B. Eco-Site, Inc. Site Plan & Conditional Use
SP# 01-18 & CU# 01-18

Purpose of Plan: To propose a 155-foot monopole wireless telecommunication tower with antennas, associated 50' x 50' fenced crushed stone or gravel compound with shelter, landscaping, and new driveway. Application Acceptance & Hearing.

Staff Report
January 10, 2018

PLAN UNDER REVIEW ENTITLED: Eco-Site, 240 Leigh Farm Rd, Durham , NC, Miller, 50 Griffin Rd, Hudson, NH, Eco-Site #: NH – 0016-B, T-Mobile Site #: 4MNO435-B, prepared by: Chappell Engineering Associates, LLC, RK Executive Centre, 201 Boston Post Road West, Marlborough, MA, dated 01 SEPT 2017 with revisions through 11 NOV 2017 and consisting of Sheets T-1, GN-1, C-1 to C-3, Z-1 to Z-5, and EC-1 (said plans attached hereto).

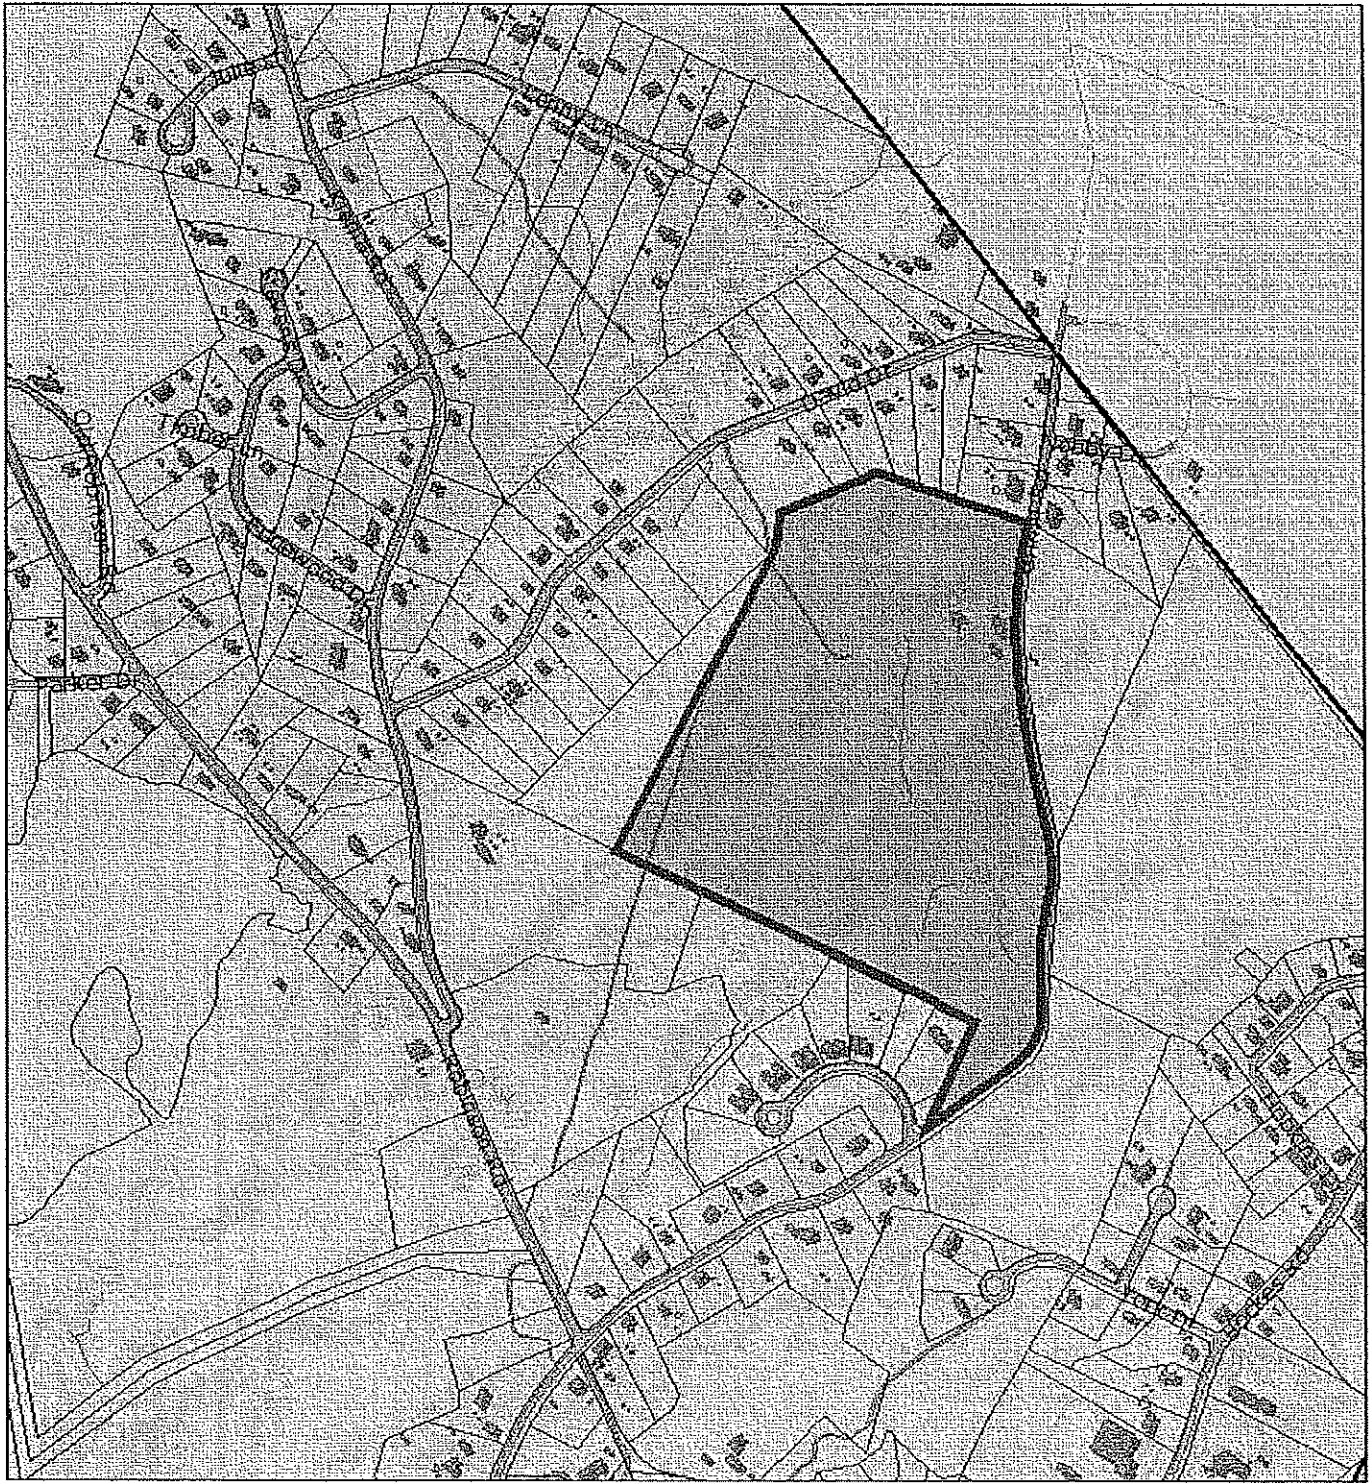
- b. ZO 334-27.1. The applicant has not shown frontage or setback lines on the plans. The applicant has noted zoning dimensions in a table on sheet C-3, which conform to the Ordinance.

- s. HR 276-11.1.B.(17). The applicant has not shown permanent monuments for the parcel boundaries on the plan set. **Permanent monuments have been called out on the plans (Sheet C-1).**

- t. HR 276-11.1.B.(20). The applicant has not shown the height of existing buildings on the plan set **Approximate heights of building shown on plans (Sheet C-1).**

- u. HR 276-11.1.B.(23). The applicant has not noted any pertinent highway projects. **No highway projects are known within the immediate area.**
- v. HR 276-11.1.B.(24)(b). Although the plan appears to meet the requirement, the applicant has not shown the lot coverage calculation on the plan set. **Lot coverage has been added to the Zoning Information chart on sheet C-3**

- b. ZO 334-27.1. The applicant has not shown frontage or setback lines on the plans. The applicant has noted zoning dimensions in a table on sheet C-3, which conform to the Ordinance. **Setback lines have been added to the plans.**
